**RECOMMENDATIONS OF THE EXPERT PANEL TO DEFINE REMOVAL RATES
FOR DISCONNECTING EXISTING IMPERVIOUS AREA RUNOFF FROM
STORMWATER DRAINAGE SYSTEMS**

DRAFT REPORT

Revised report presented to and approved by USWG, ~~TBD~~ [September 20, 2016](#)

| Appendix F: Panel Response to Comments | | 103 |

Figure 13. Comparison of CN values using MDE method and Chong & Teng (1996) for indicated soil types. These values are for pre-amendment conditions.

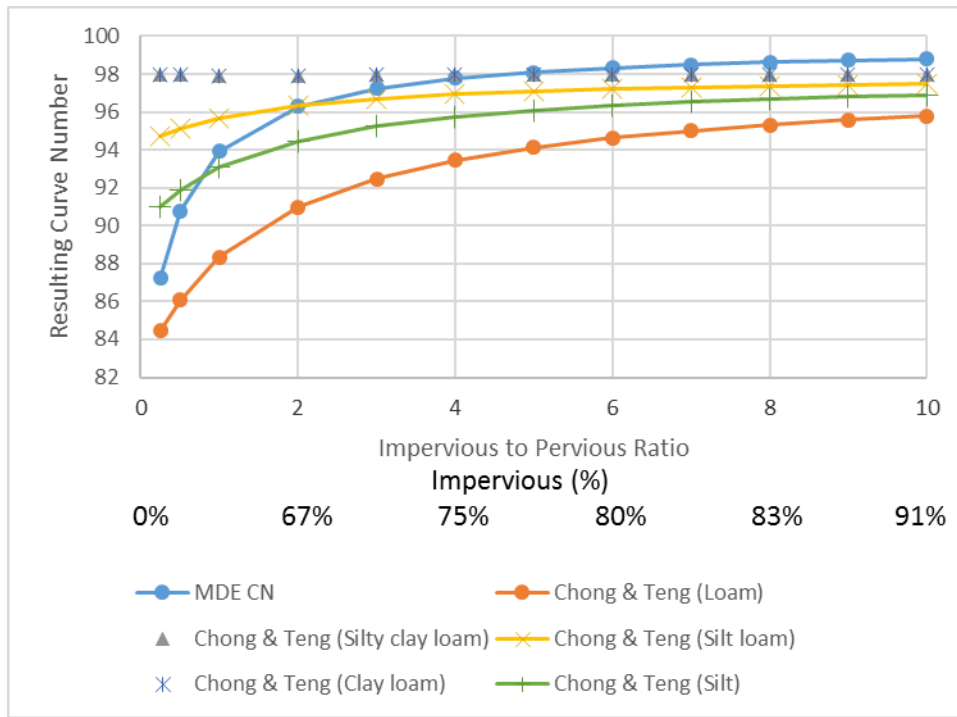
- 4) Runoff methods suggested, for example, in Appendix D.10 of the Maryland Stormwater Manual (Method for Computing Peak Discharge for Water Quality Storm), which uses methods from Claytor and Schueler (1996) and Pitt (1994), addresses the accuracy issues associated with predicting runoff volume from small storms. However, changes to onsite soil characteristics cannot be quantified (i.e. runoff reduction from amendments is zero) as there is no way to relate changes in saturated hydraulic conductivity to runoff volume.

- a. Though runoff reduction cannot be calculated using the MDE method, a comparison is possible between the resulting CN from this method and pre-soil amendment CN. The purpose of Figure 1 below is to show the initially high CN values (potentially leading to high runoff estimates) using the Chong and Teng method. Thus, when compared to the MDE approach, this method takes into account soil characteristics differences while still providing a similar trend.

Figure 2. Runoff Reduction comparison of initial abstraction (I_a) assumptions for a Loam soil amended with compost and subsoiling (consistent with Schwartz & Smith, 2016).

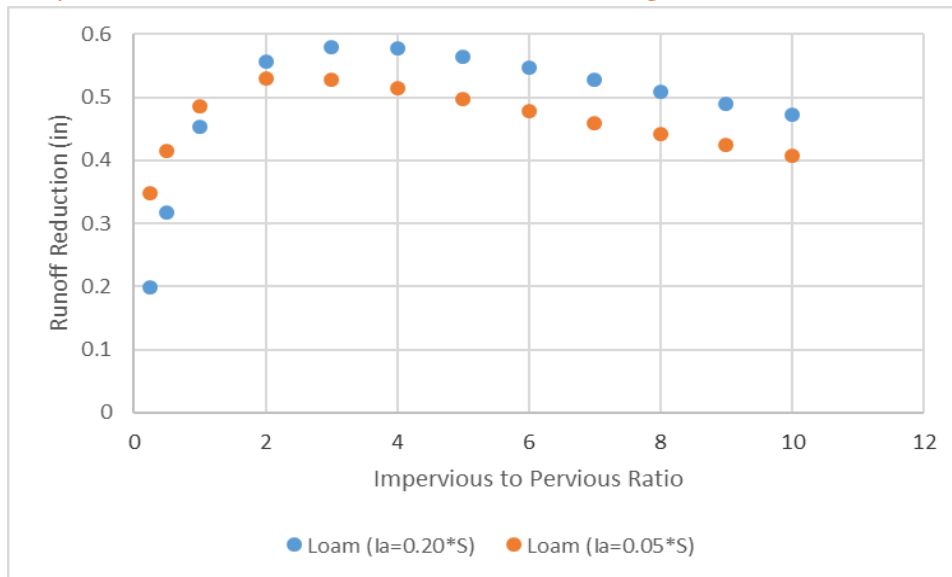
Recent research has focused on different initial abstraction factors (e.g., 0.05) instead of the current factor (0.20) used in the RCN approach. This might address the small storm issue. MDE suggested that we look at how a change in the initial abstraction factor might change the predicted runoff reduction volume using the Expert Panel method. The results show that there is a 0.15 inch maximum difference in runoff reduction estimates between an Ia of 0.2 and 0.05 for the loam with heavy soil amendments considered in the Schwartz example above. When runoff reduction values are converted into water treated per impervious acre then put into the retrofit adjuster curves for total nitrogen reduction, for example, there is a (-)7% to 4% difference in these two assumptions for the specified amendments. As can be seen in Figure 2, the largest difference comes with a low Impervious to Pervious Ratio, where the 0.05 assumption is predicting more runoff, though this is likely due to near zero runoff estimates in this example.

Figure 3. Runoff Reduction comparison of initial abstraction (I_a) assumptions for a Loam soil with 1 inch of compost incorporated 4 inches into the existing soil (light amendment).

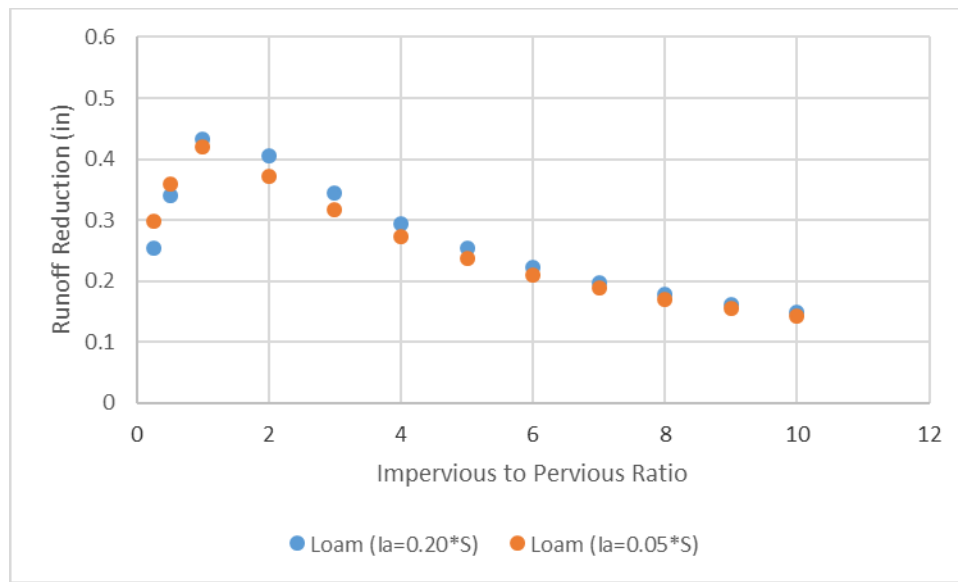
Considering a loam with light soil amendments (1" compost incorporated 4" into existing soil), a maximum difference in runoff reduction is 0.04 inches (Figure 3). The sharp drop after Impervious to Pervious ratio of 1 in the light amendment example is due to underlying soil not being amended. We recommend not adding this layer of complexity since the bias associated with an $I_a = 0.2$ is relatively small for the expected RCN values used in the panel's protocol; however, if this change is consistent with recommendation from other expert panels or if this assumption will not add confusion to implementation of these protocols, the expert panel may be amenable to the change.
